TOWN OF GLASTONBURY
GL-2021-05
GLASTONBURY HIGH SCHOOL ATHLETICS FACILITY
ADDENDUM NO. 2
December 10, 2020

A. RFI Questions and Answers:

C. Drawing Clarifications/ Revisions:

7 Alt 1 Building Section 1
1/4" = 1'-0"

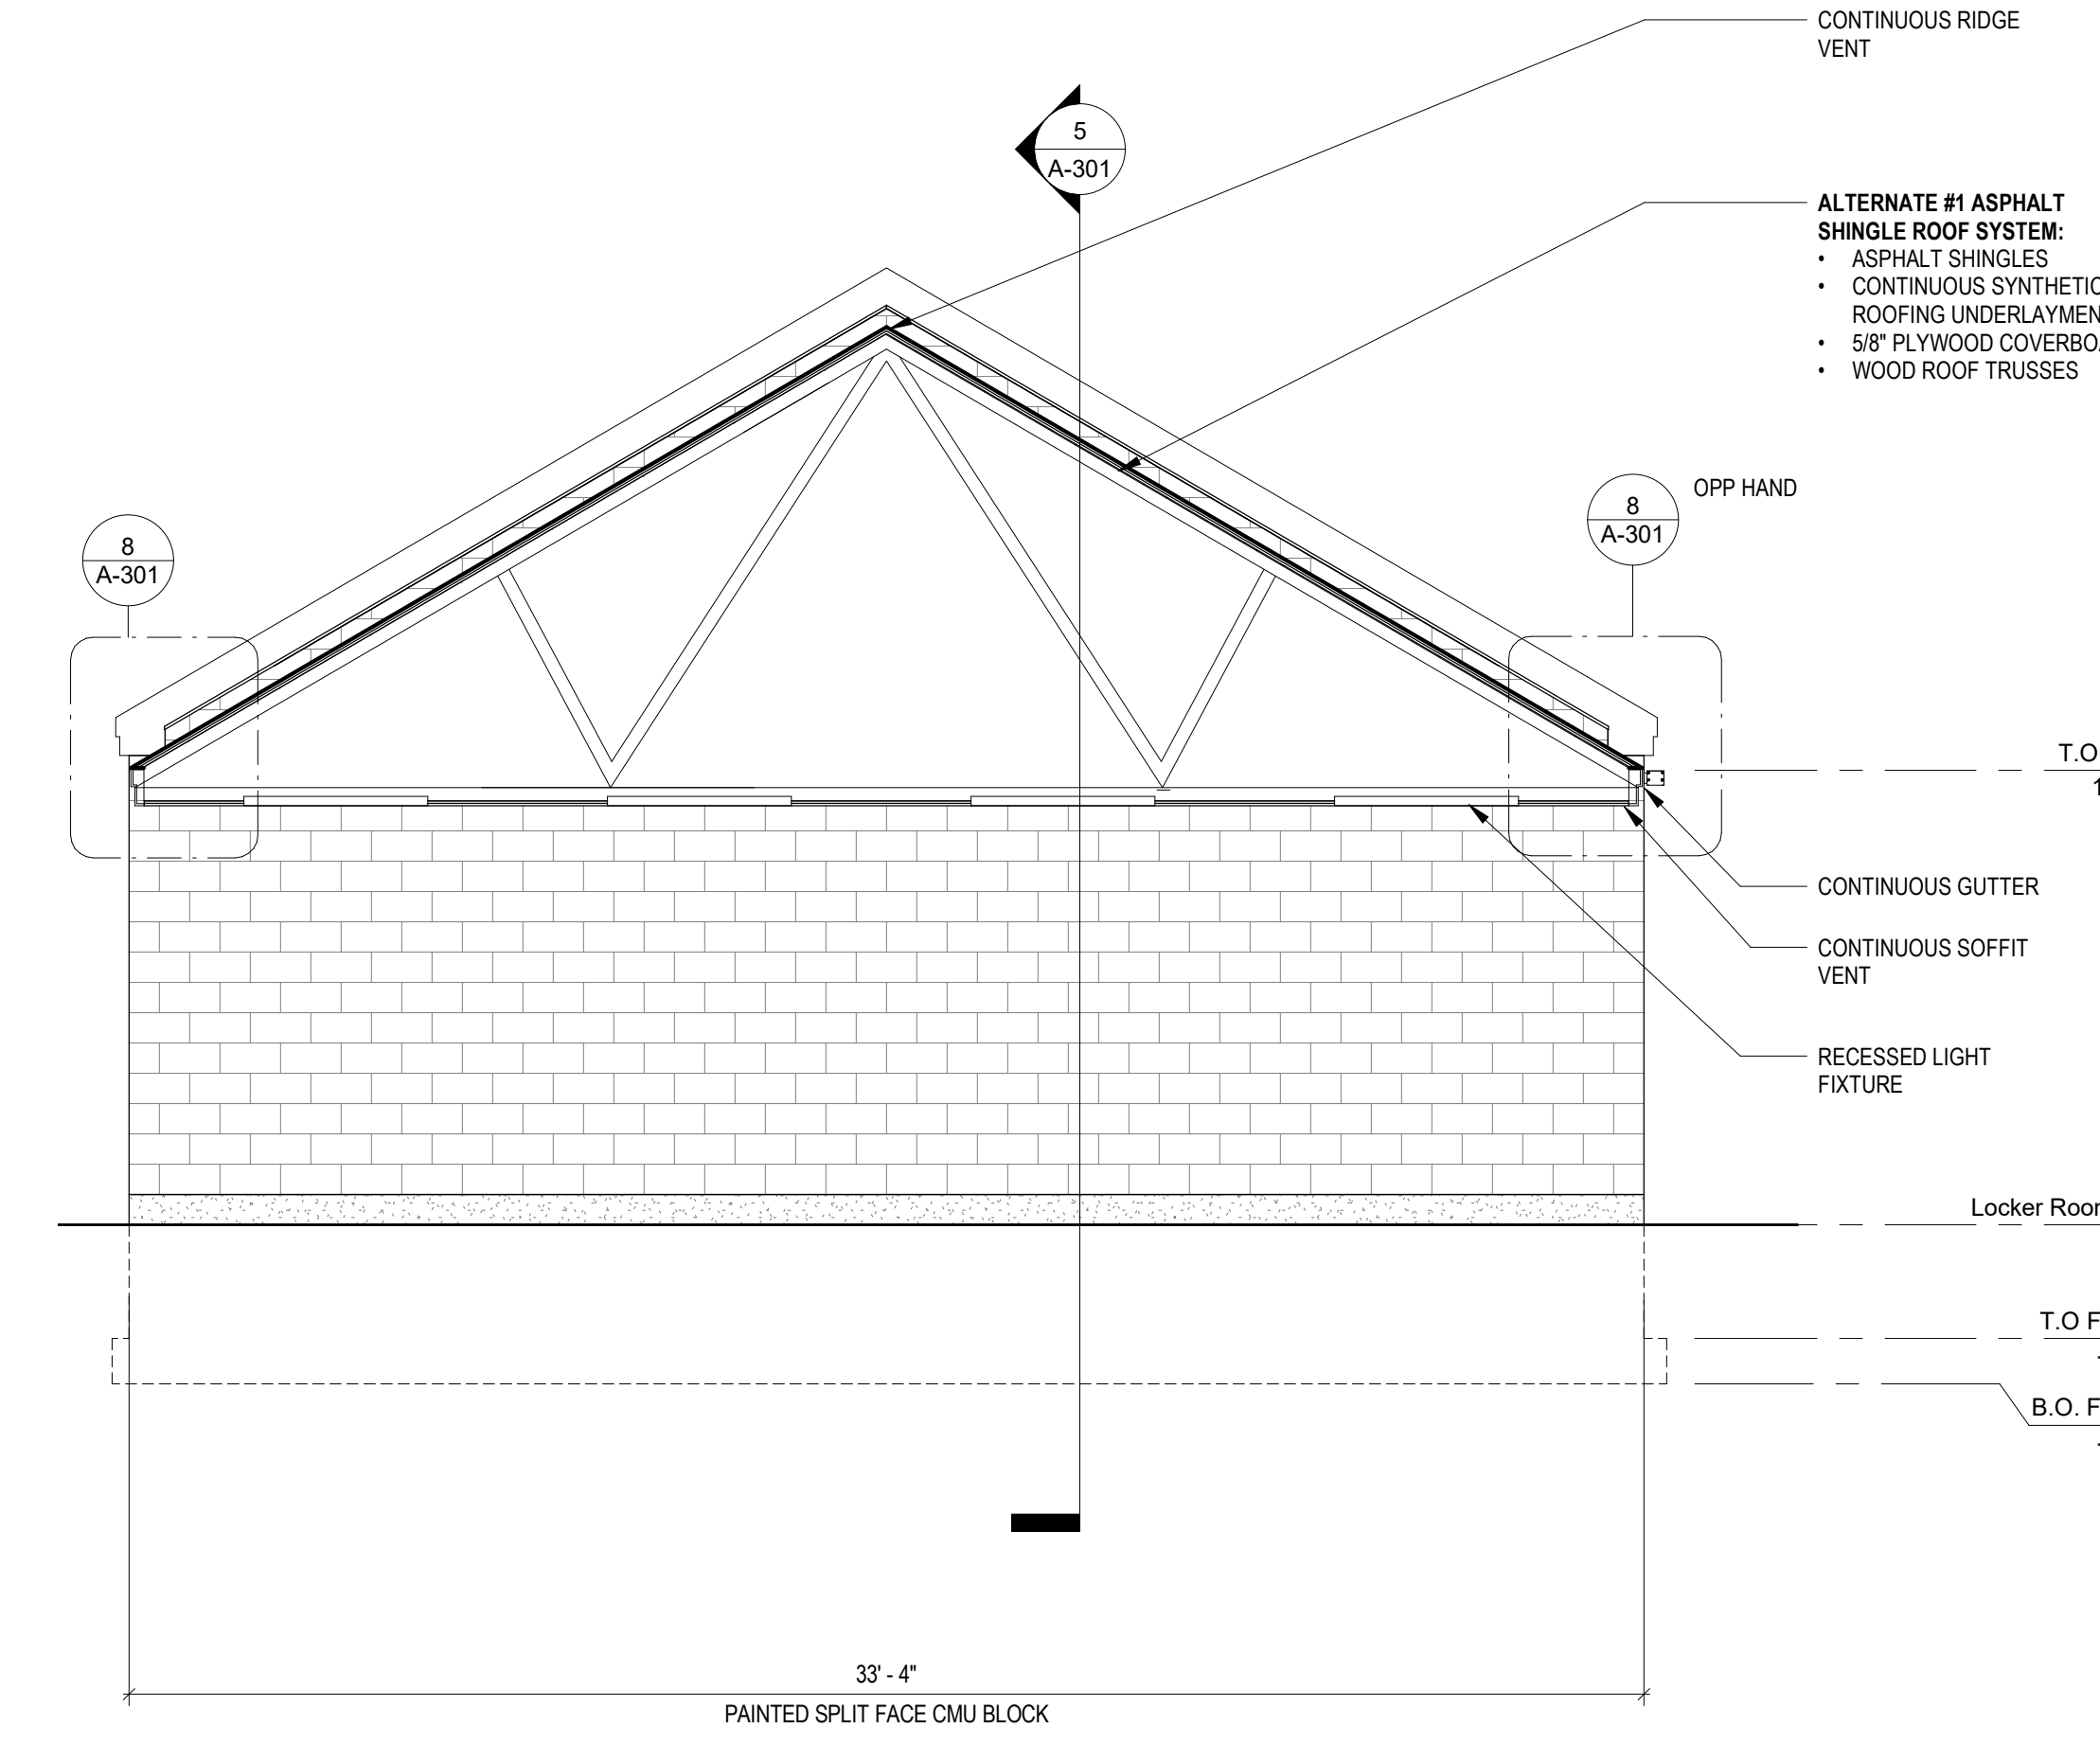
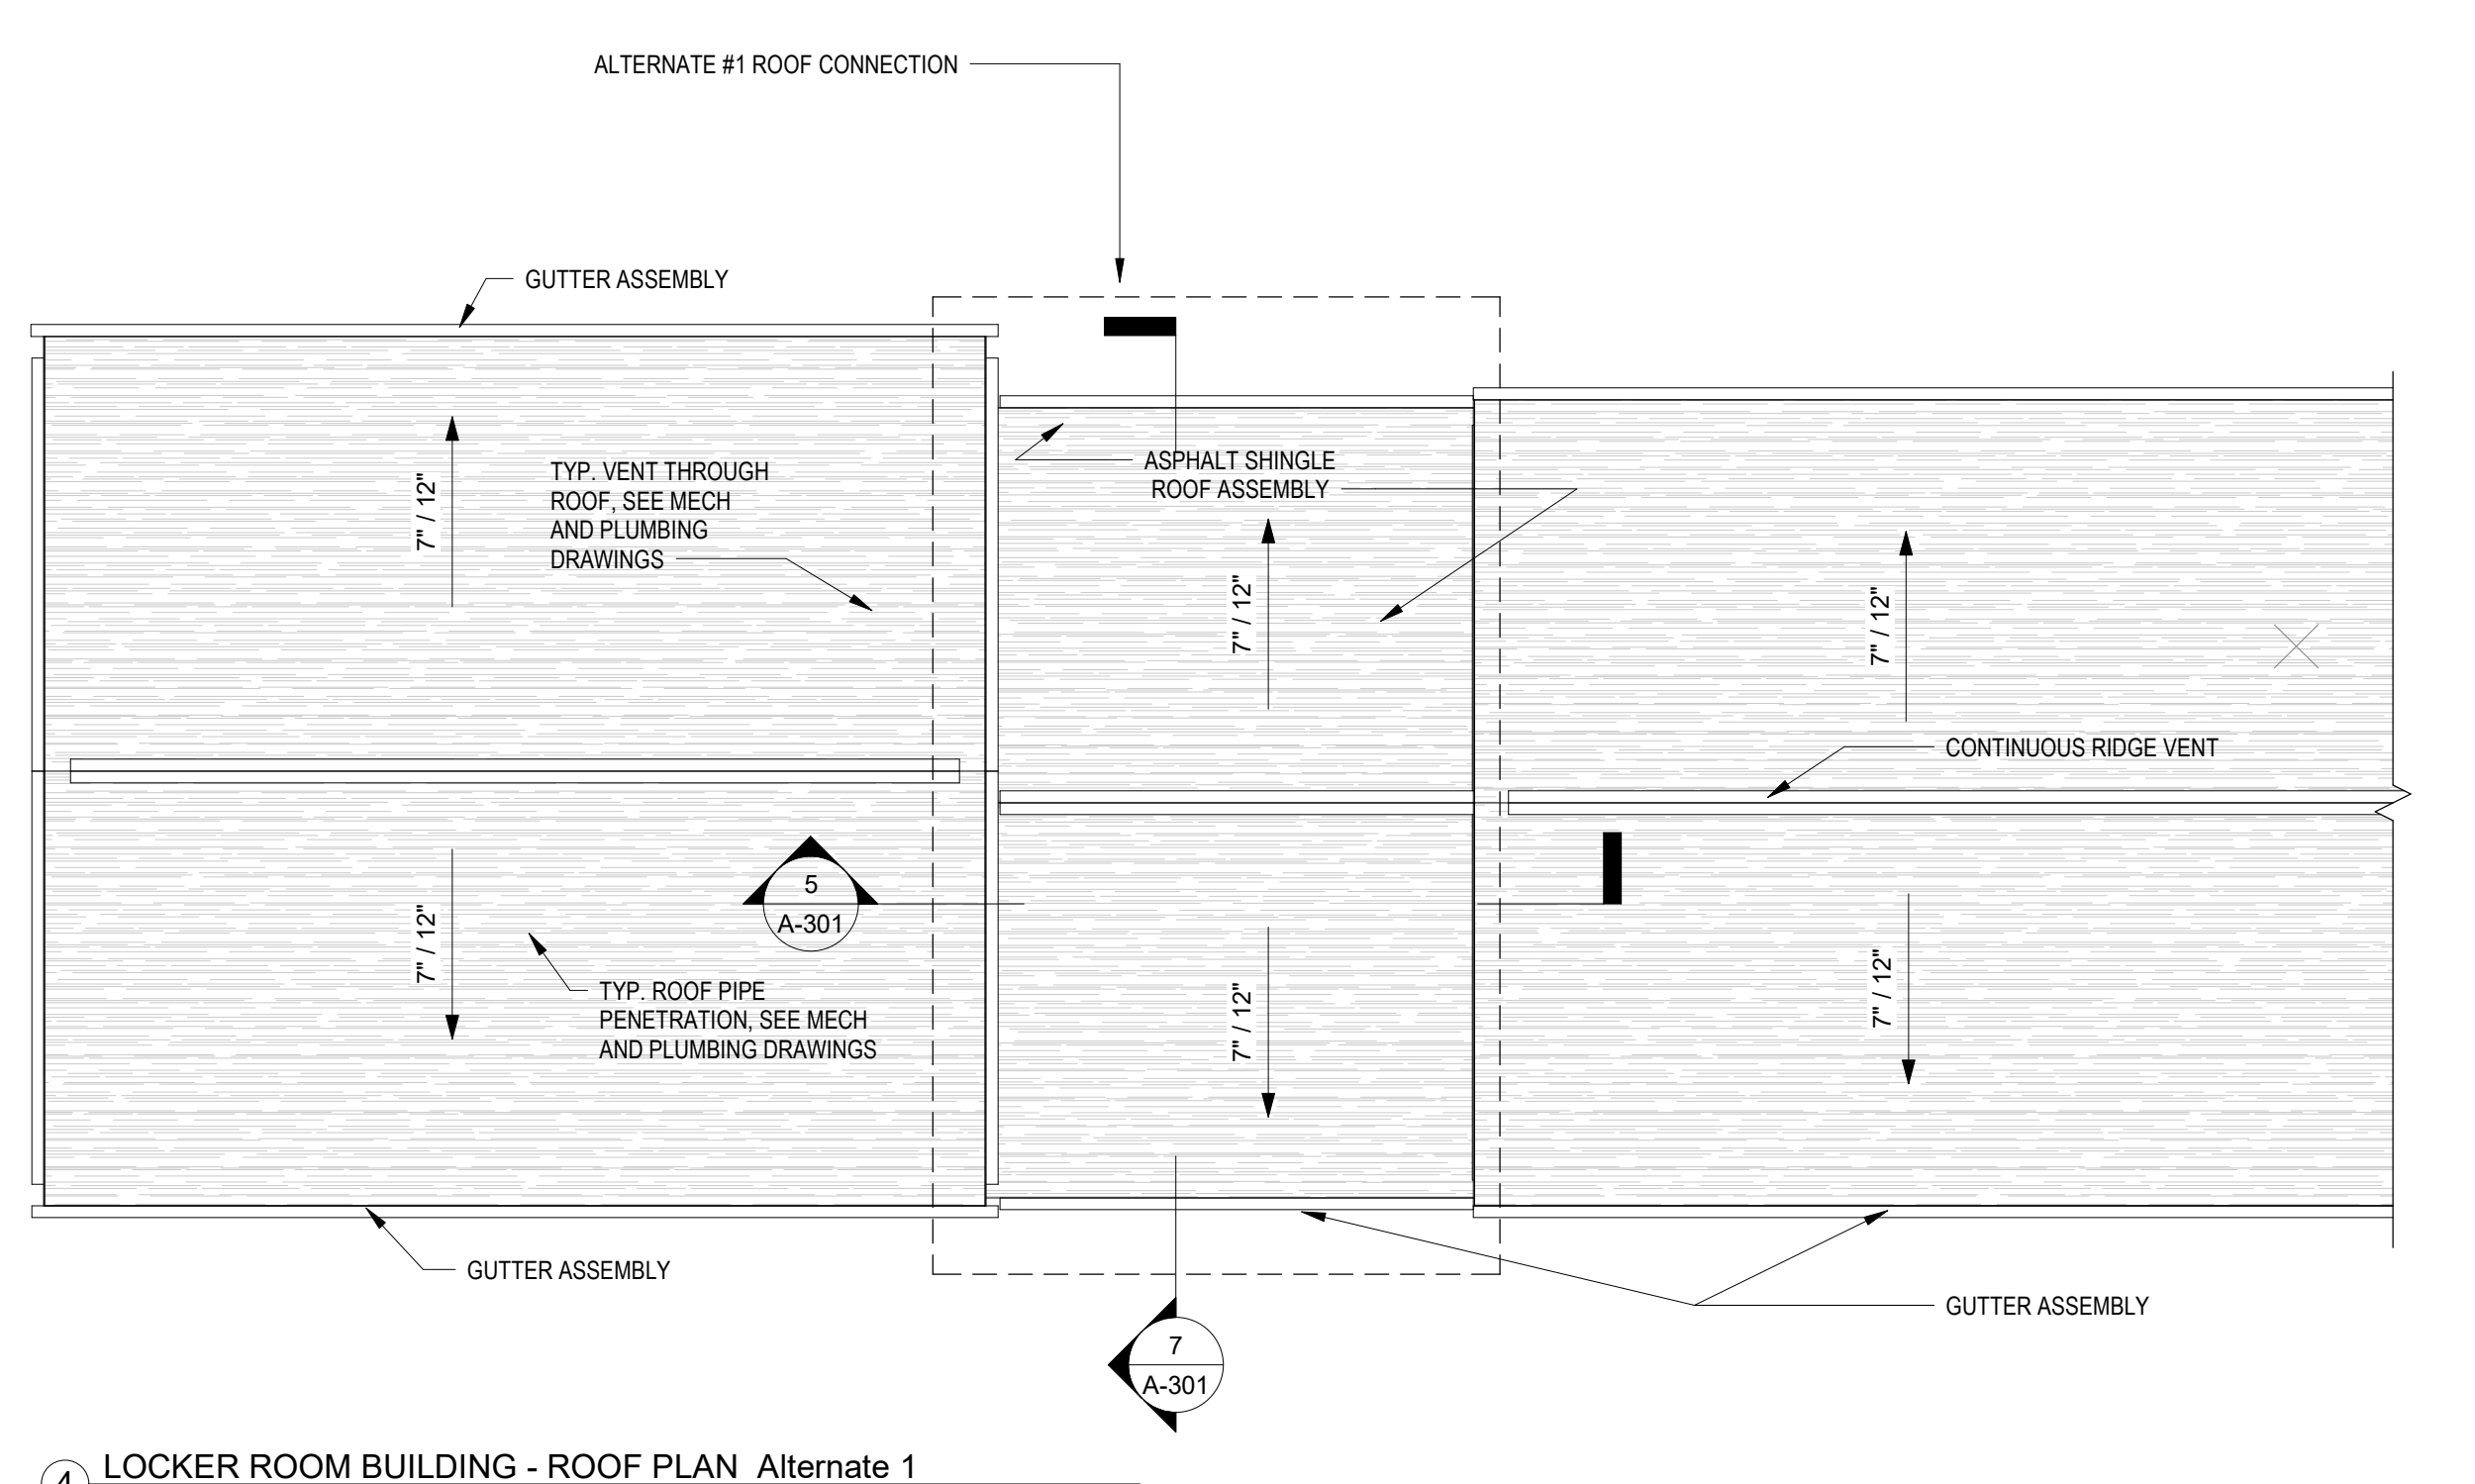
Question 28: *Drawing A-301 shows the Breezeway roof connecting the 2 structures. However, there are no cross sections, details, or structural drawings for this roof section. Please provide.*

Answer: Refer to A-301 and S4.1 included with this addendum for added details, sections, and structural details.

Item #5	C-5.0		REPLACED drawing C-5.0 with revised drawing dated 12/10/2020
Item #6	S-4.1		ADDED drawing S4.1 “Connector Roof Alternate”
Item #7	A-301		REPLACED drawing A-301 with revised drawing dated 12/10/2020. ADDED reflected ceiling plan, building sections, and details describing Alternate #1 Roof Connector.

FF&E PLAN SCHEDULE
1/8" = 1'-0"

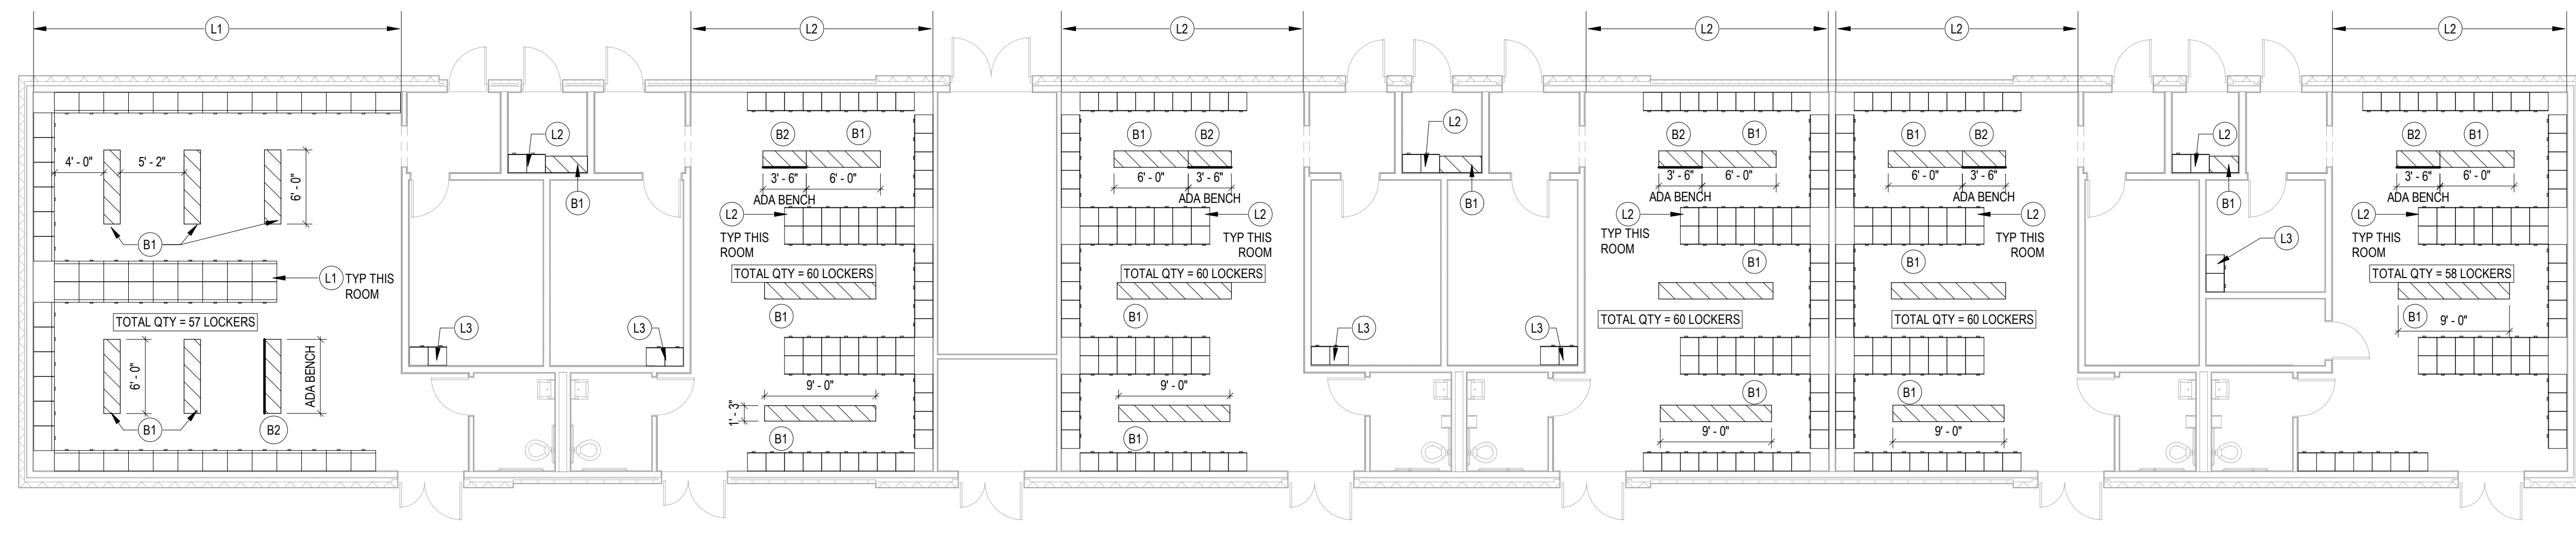
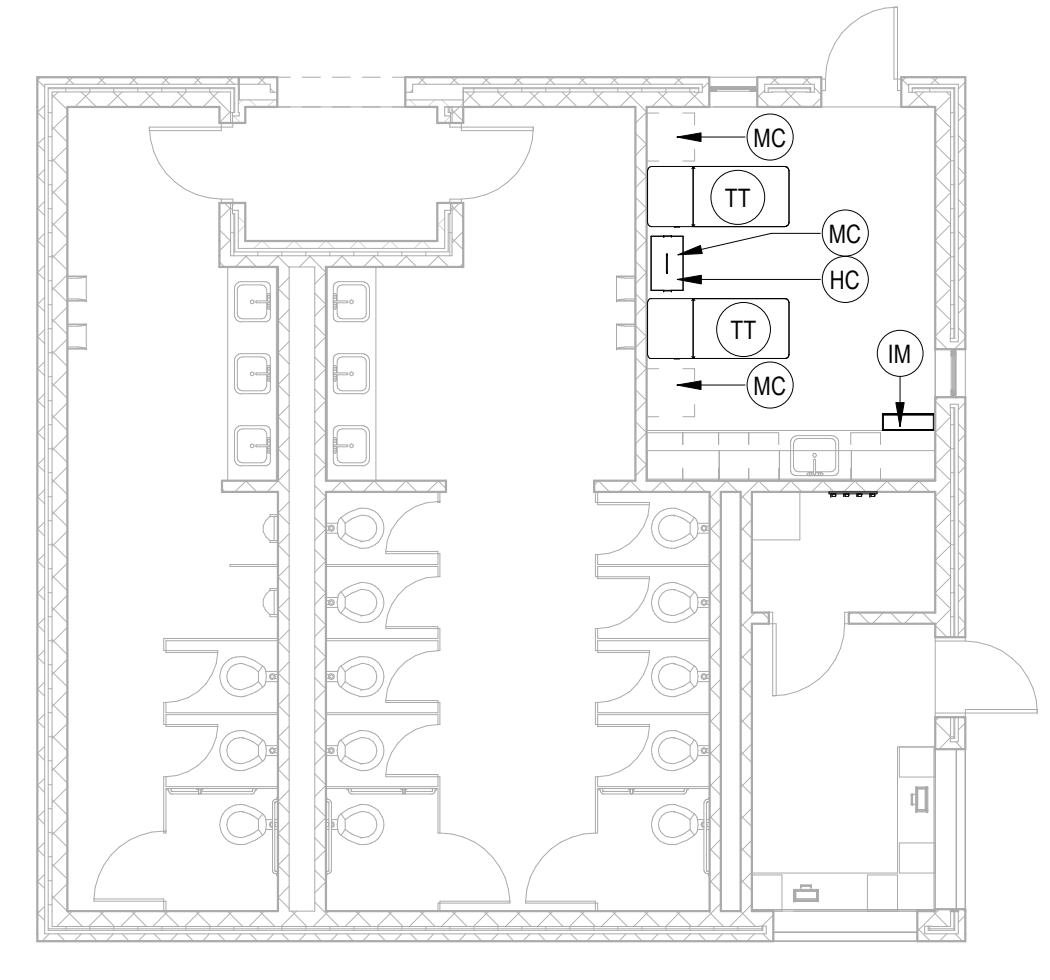
Question 3: *Alternate #4 on the Bid Form requires a price to furnish and install lockers, benches and training room equipment. Please provide appropriate specifications and layouts of the required items and equipment.*

Answer: Refer to drawing A-910 included with this addendum for FF&E layout and specifications.
